APPENDIX A:

Facility Reports

City Hall - Exterior
2600 Fresno Street, Fresno

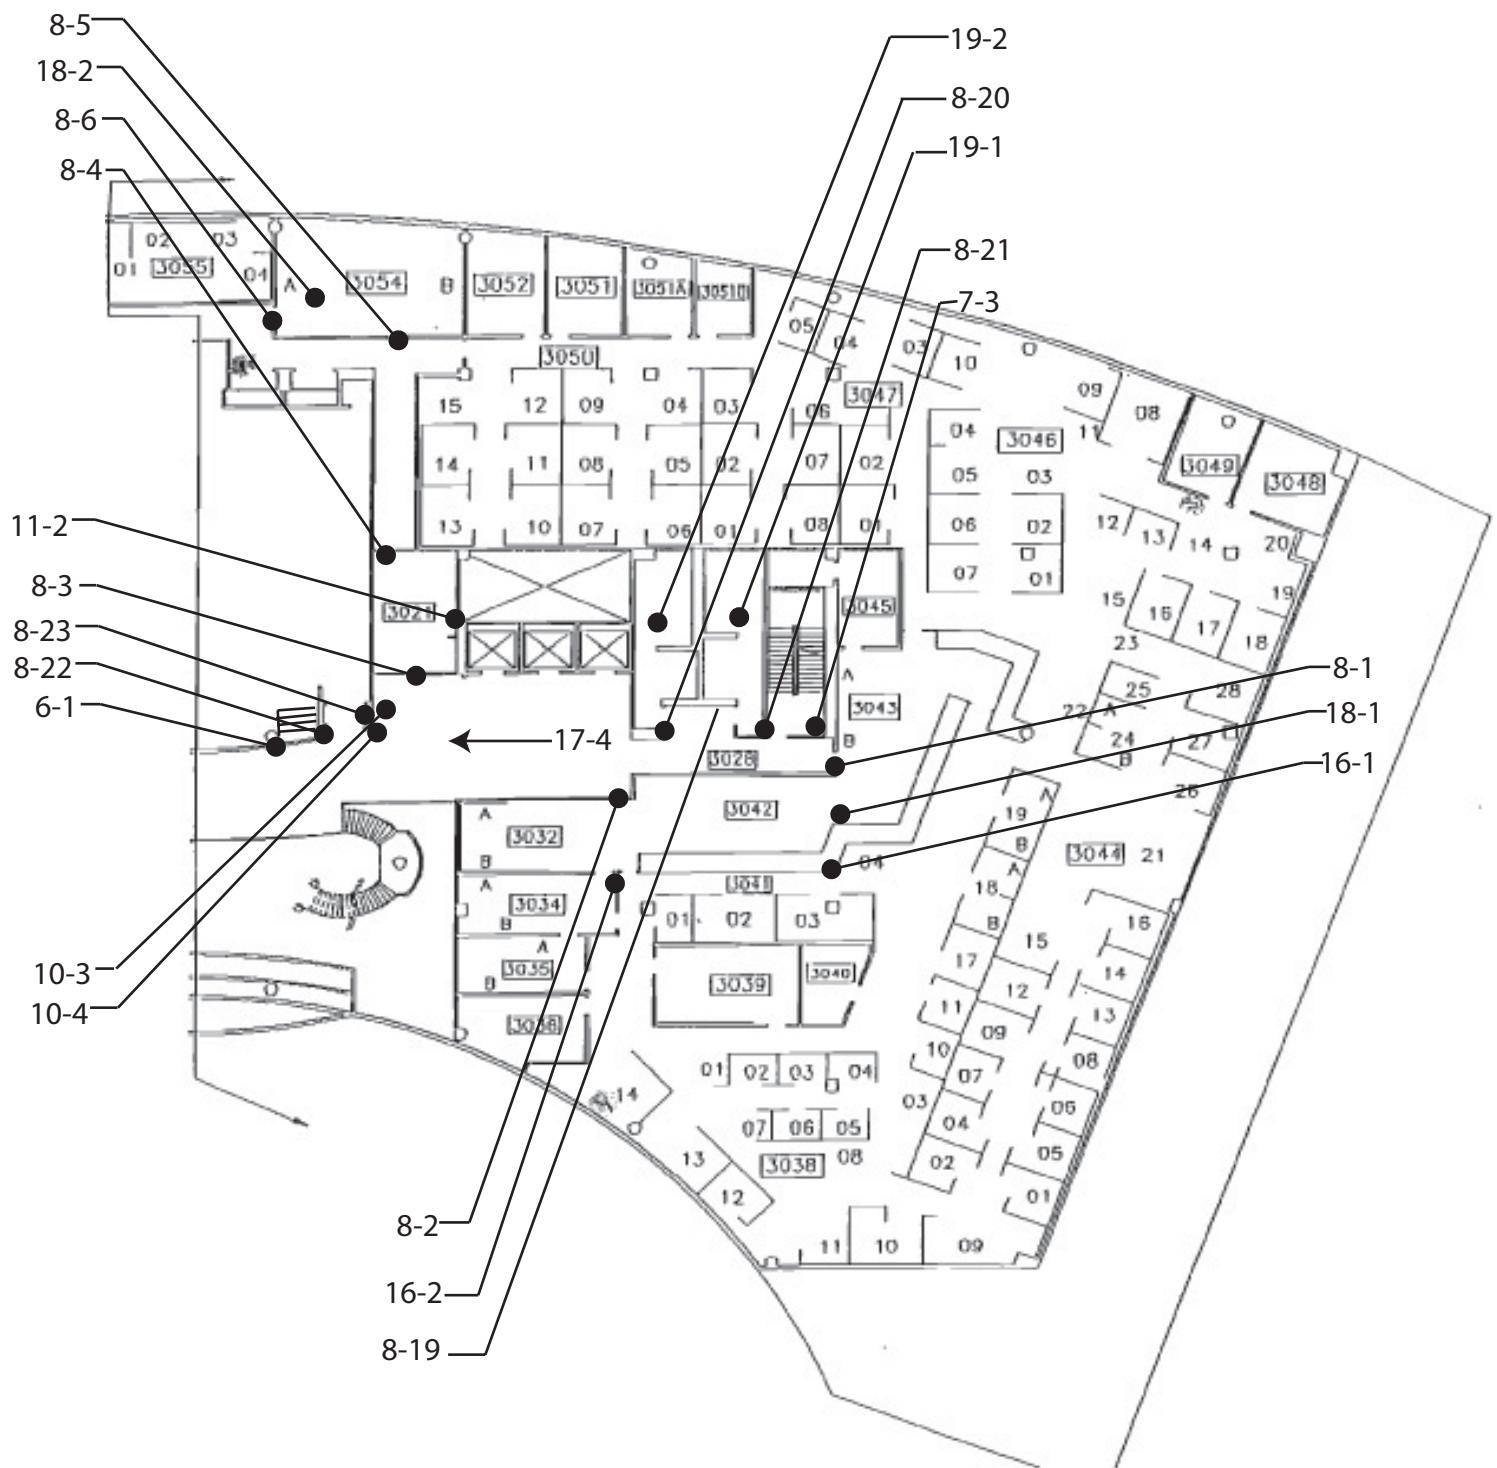
Install sign

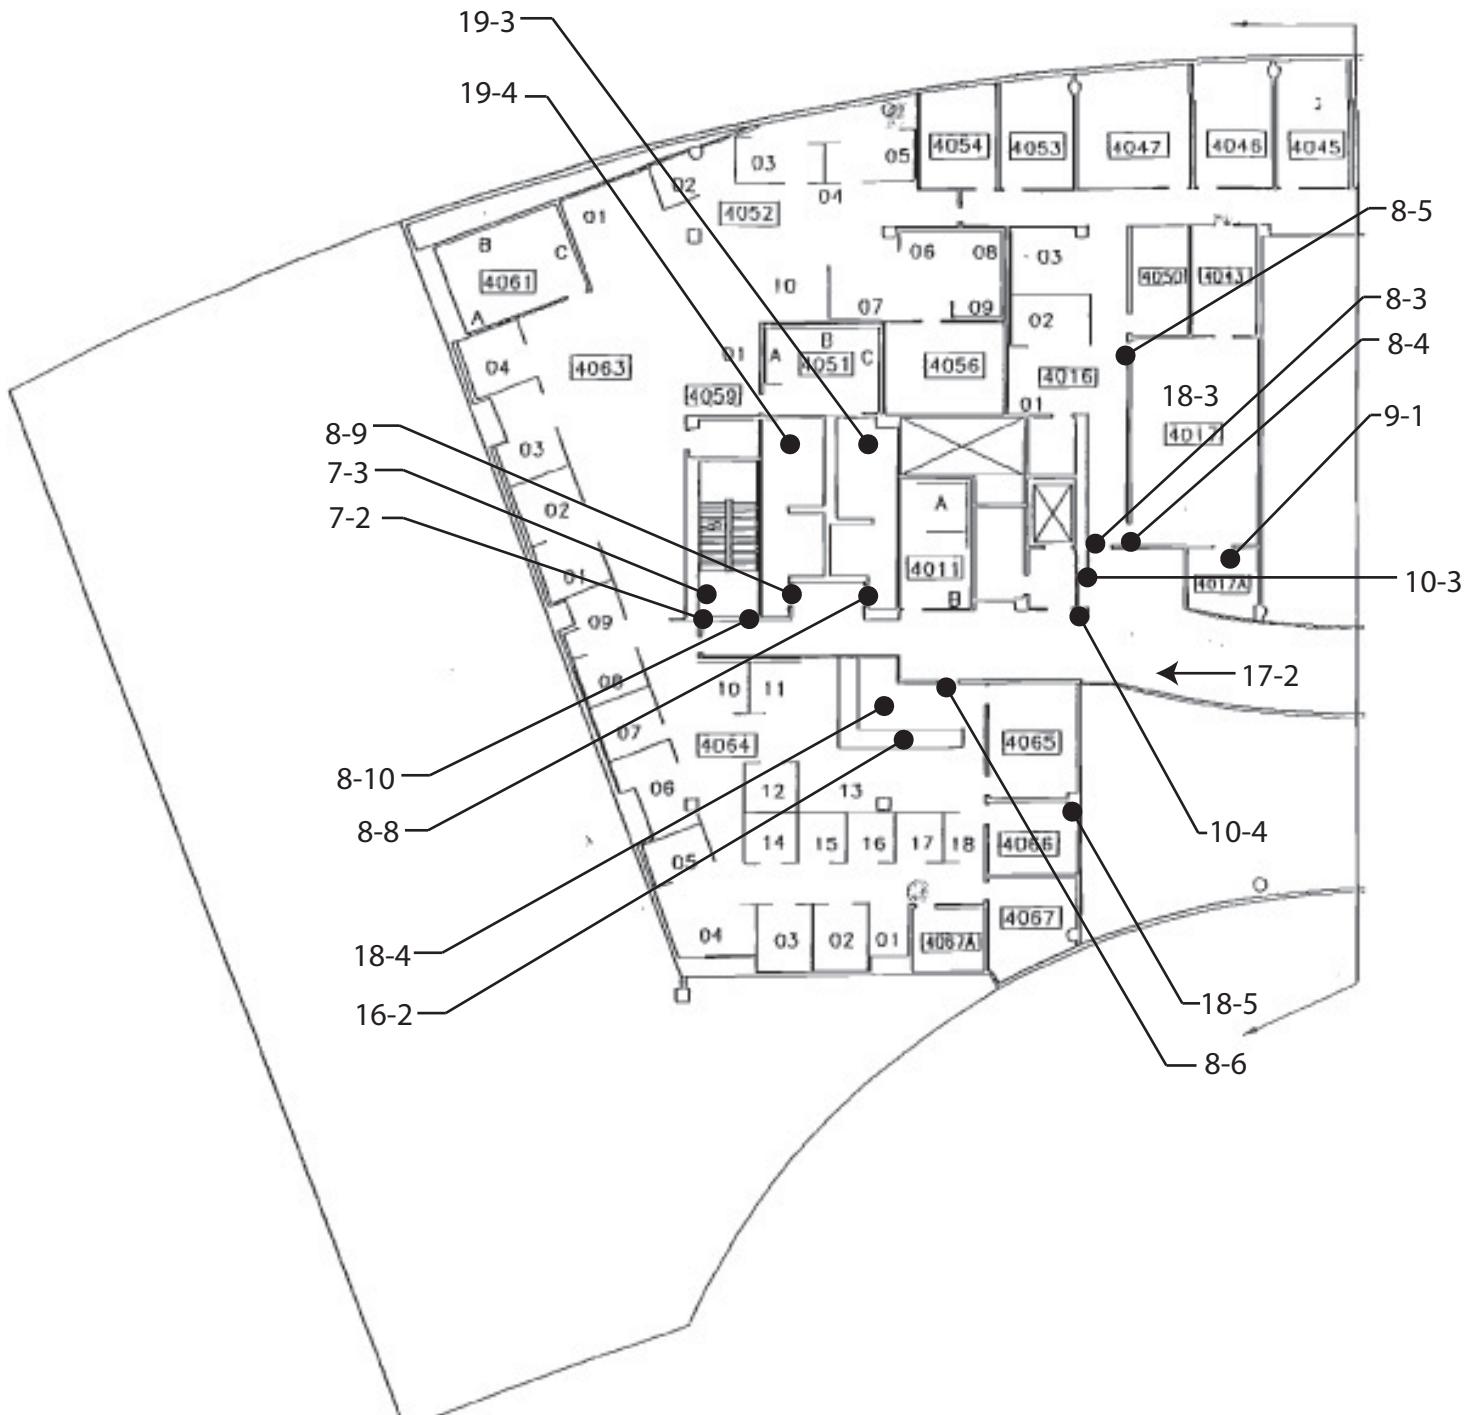
Replace or reposition fixtures

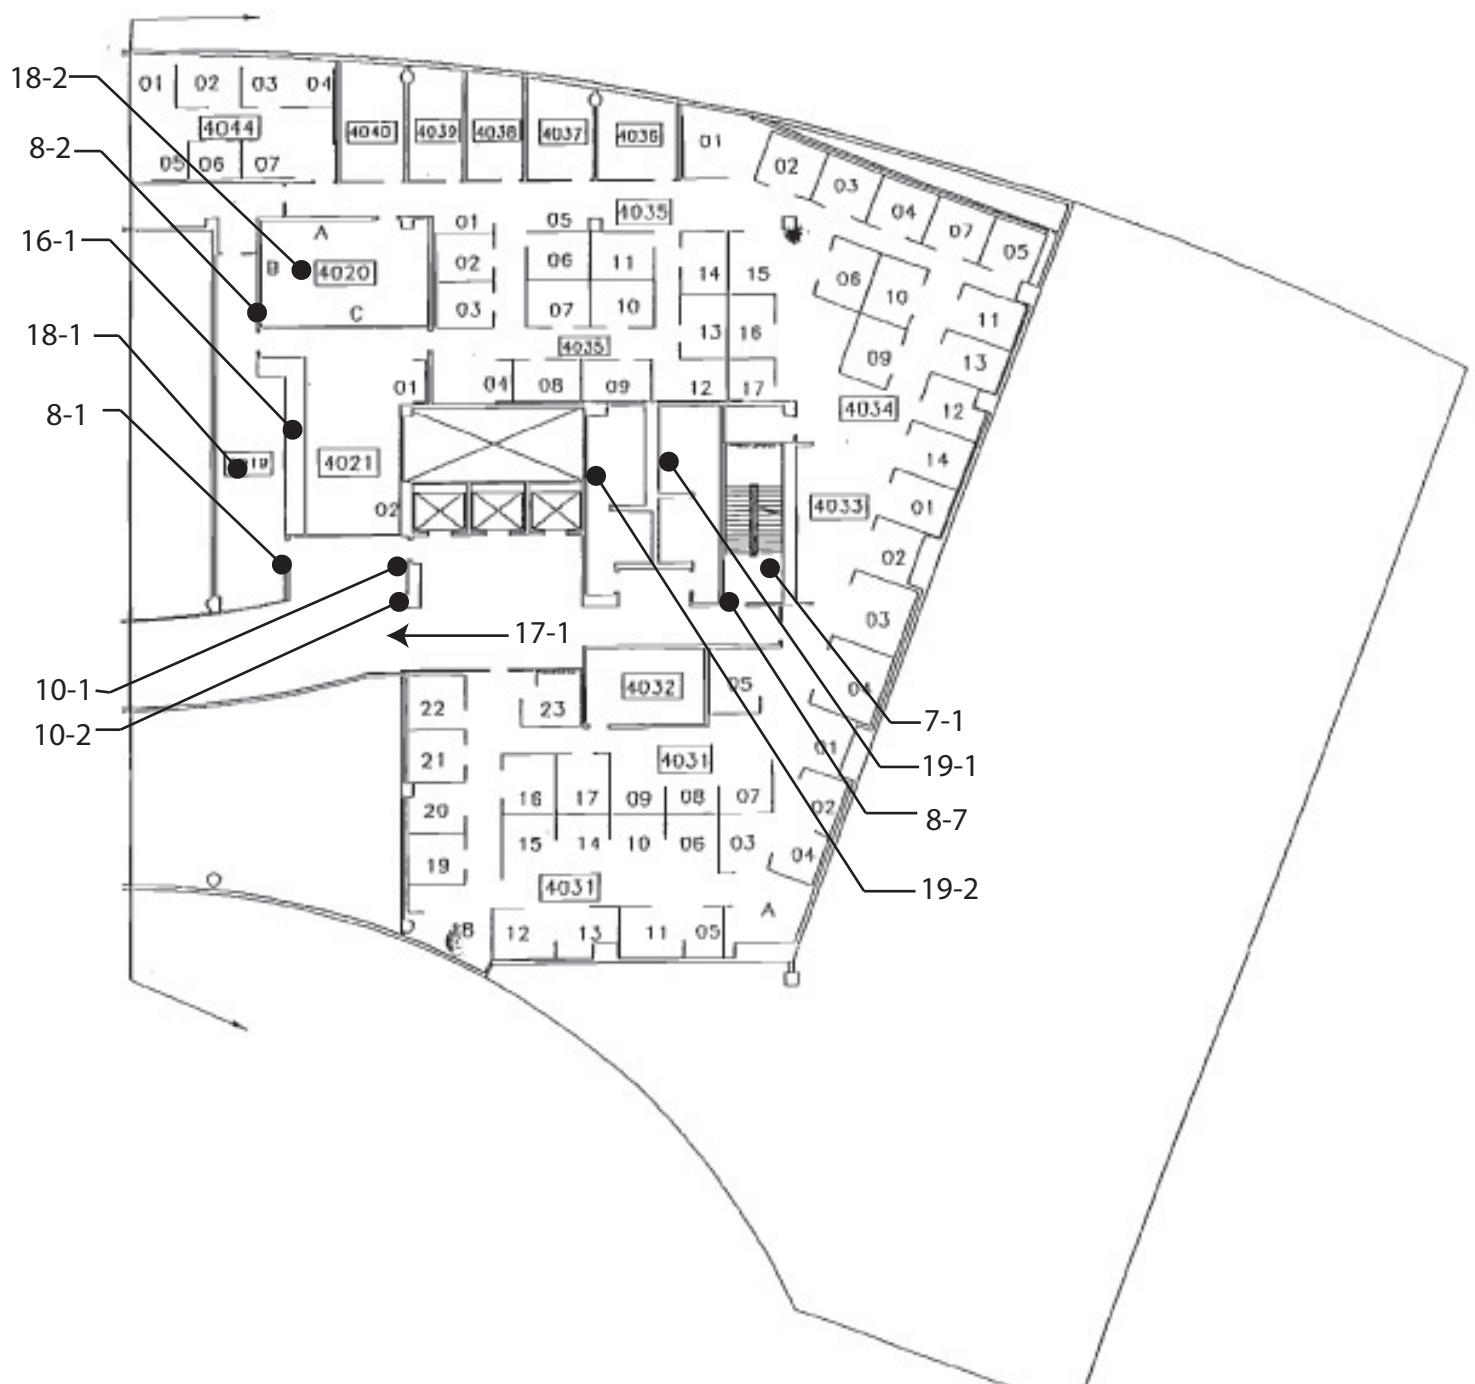
Reposition toilet flush controls

Basement B**19 - 2 Multiple User Restroom**

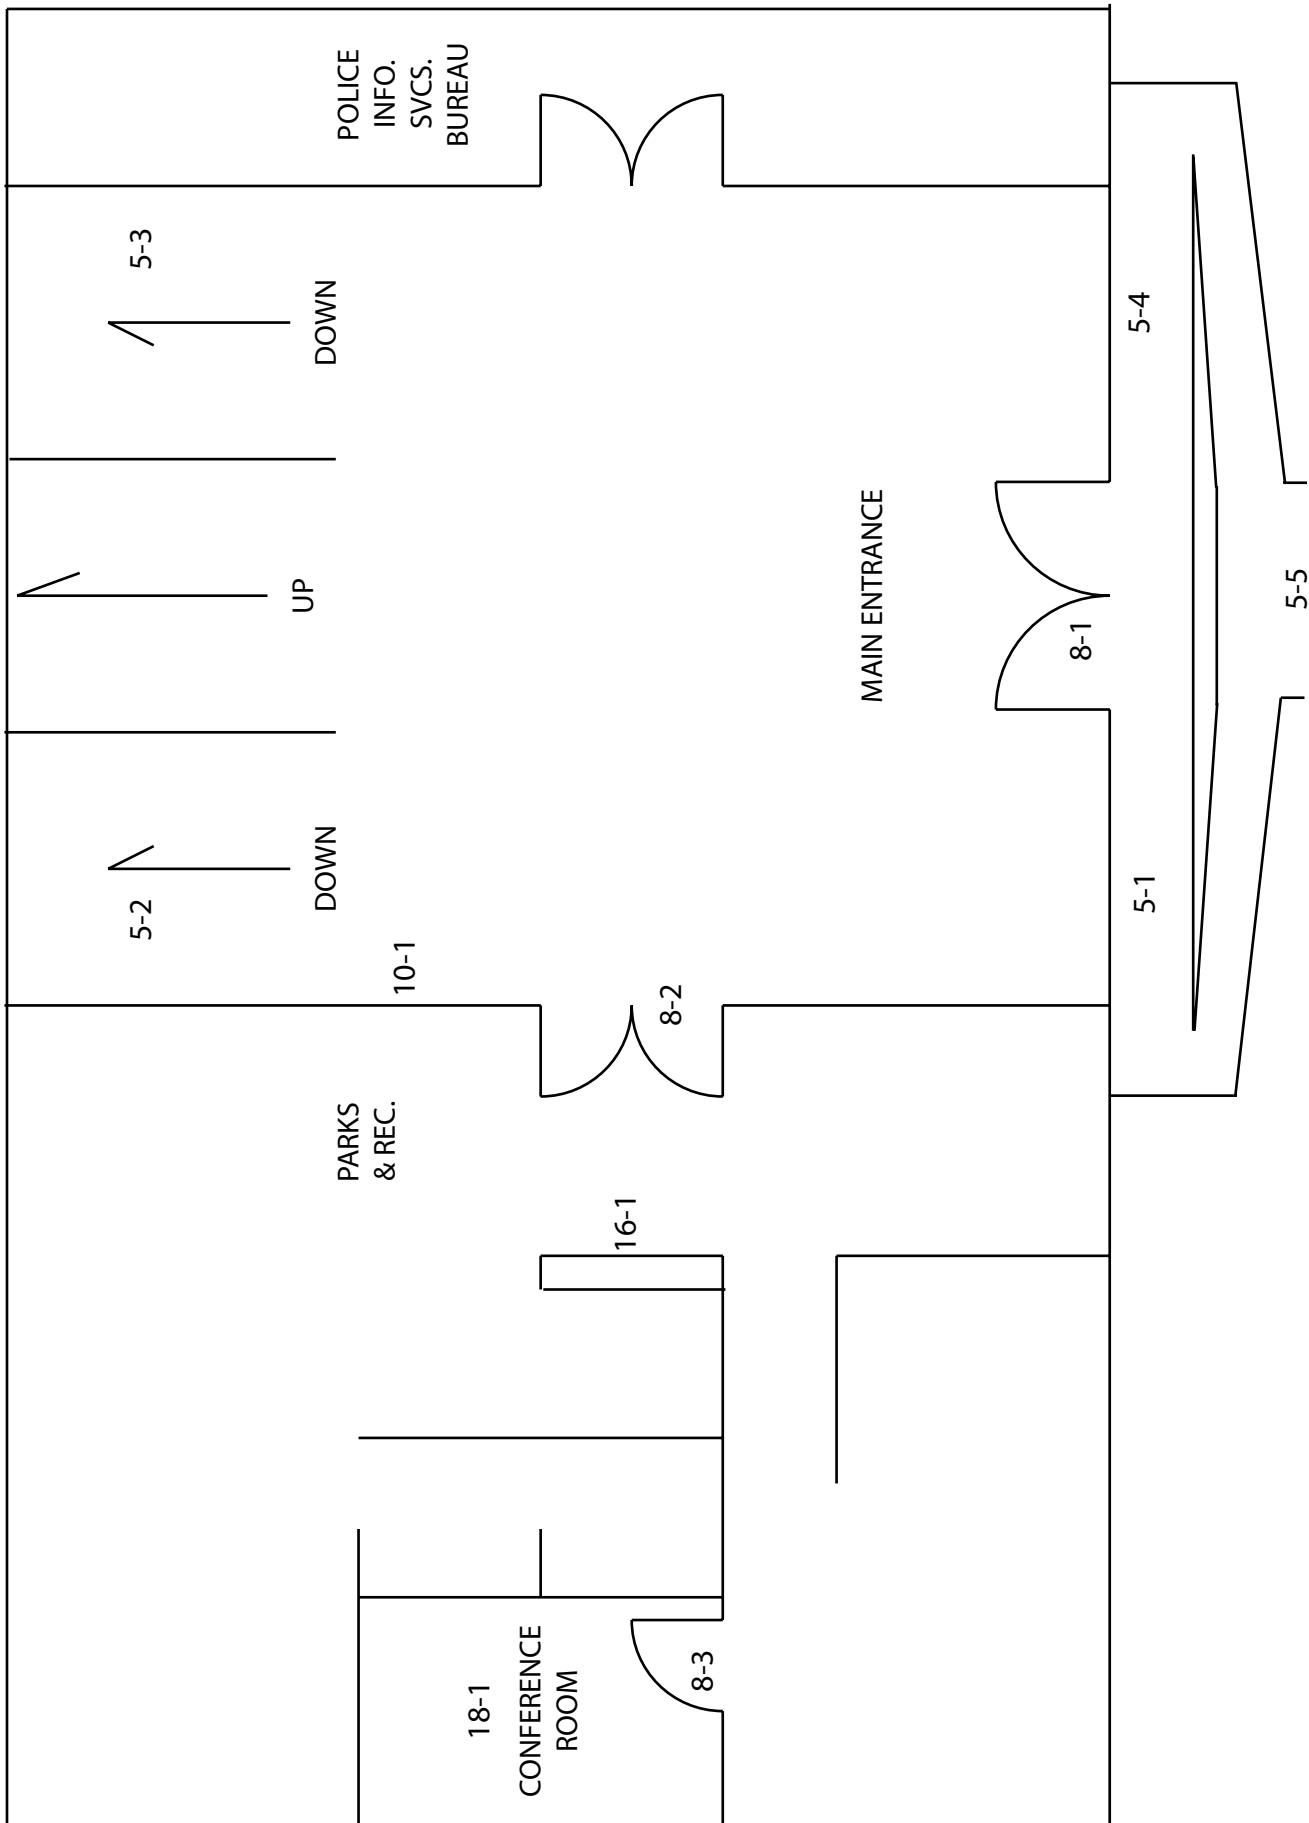
19 - 2	Multiple User Restroom	Priority:2
Provide an accessible path of travel		\$2,000
Notes: Door opens onto stairs leading down to restroom (there must be an accessible route to the restroom). Design study required.		
State: 1115B.1		
Federal: 4.22		
Install sign		\$250
Notes: California required signage is not provided on the door.		
State: 1115B.6		
Federal: 4.30.4		
Install sign		\$250
Notes: Federal required signage is not provided on the latch side of the door.		
State: 1115B.6, 1117B.5.1 #1		
Federal: 4.30.4		
Replace or reposition dispensers or mirrors		\$200
Notes: Mirror is mounted so bottom of reflecting surface is 49" (40" max) above the finished floor.		
State: 1115B.8.1		
Federal: 4.19.6		
Replace or adjust water controls		\$500
Notes: Control for the lavatory sink requires grasping and twisting.		
State: 1115B.8.3		
Federal: 4.19.5, 4.27.4		
Replace or reposition dispensers or mirrors		\$500
Notes: Towel dispenser is 67" from the floor; sanitary napkin dispenser coin slot is 49" from the floor (both 40" max).

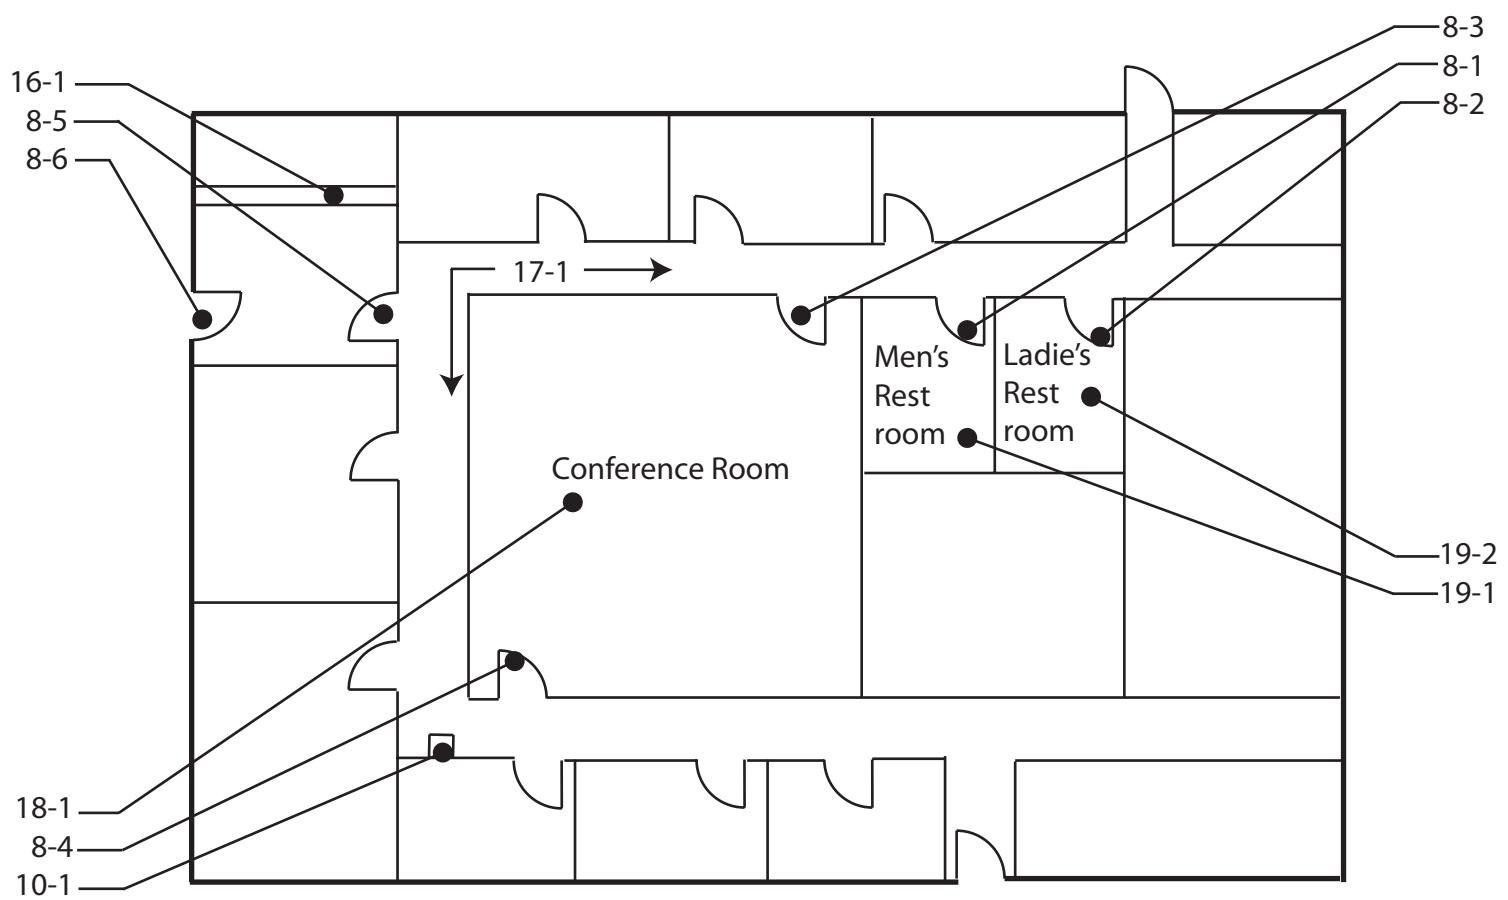
Exterior	
3 - 1 Curb Ramp	Priority: 4
Install, replace or modify curb ramp	\$2,500
Notes: Slope is 11.8% (8.33% max). Level landing is not provided.	
State: 1127B.5 #3, 1127B.5 #4	
Federal: 4.8.2	
Provide surface texturing	\$0
Notes: Surface material does not contrast with surrounding sidewalks.	
State: 1127B.5 #5	
Federal: -	
Repair surface	\$250
Notes: Surface level changes exceed 1/4" (1/4" max).	
State: 1133B.7.4	
Federal: 4.7.2	
3 - 2 Curb Ramp	Priority: 1
Provide detectable warning strip	\$1,000
Notes: Detectable warnings are not provided.	
State: 1127B.5 #7	
Federal: 4.7.7	
32 - 1 Picnic Area	Priority: 4
Provide an accessible table	\$1,000
Notes: Accessible picnic table does not provide 1 wheelchair seating space.	
State: 1132B.3.1 #2	
Federal: 306.3	
Replace or reposition picnic grill	\$750
Notes: Cooking surface is 45-1/2" (15" - 34" max) above the finished floor.	
State: -	
Federal: 308	
34 - 1 Fixed Bench	Priority: 4

Provide accessible fixed bench	\$900
Notes: Back support is not provided. Armrests are not provided.	
State: -	
Federal: -
